American Telecommunications Certification Body Inc.  
6731 Whittier Ave, McLean, VA 22101

RE: Shure, Inc.

FCC ID: DD4UR1HF

After a review of the submitted information, I have a few comments on the above referenced Application. Depending on your responses, kindly understand there may be additional comments.

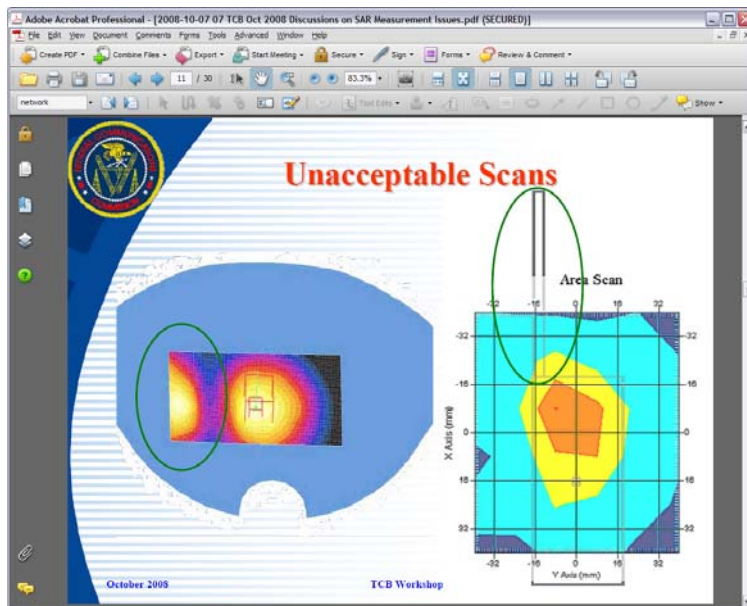
- 3) FYI...For the 731 form I am showing that the power should be listed as frequency tolerance of 4058 Hz, and emissions designator of 125KF3E (Carson's rule for Analog devices).

[See updated 731 Form.](#)
